SERVICE BULLETIN

M-1179

SAFETY RECALL-2006 FLHXI MIRROR RELOCATION

Figure 1. Drilling Template Position

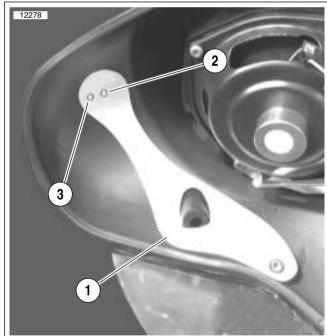
- Obtain a drilling template. One template is included in each decal kit and in each mirror kit.
- 2. See Figure 1. Place template (1) on inside of inner fairing as shown to locate mounting holes for mirror. Make sure entire template lays flush against fairing contour.

- Begin by drilling a 1/8 inch (3.175 mm) pilot hole at each location (2, 3) marked on the template. Remove template.
- 4. For the center hole (2) where the 3/8 inch (9.525 mm) threaded stud passes through the fairing use a 13/32 inch (10.319 mm) diameter twist drill to drill the hole to its final size. For the alignment hole (3), use a 7/32 inch (5.556 mm) diameter twist drill to drill the hole to the final size.

- 1. Template
- 2. Location of 13/32 inch center hole
- 3. Location of 7/32 inch alignment hole
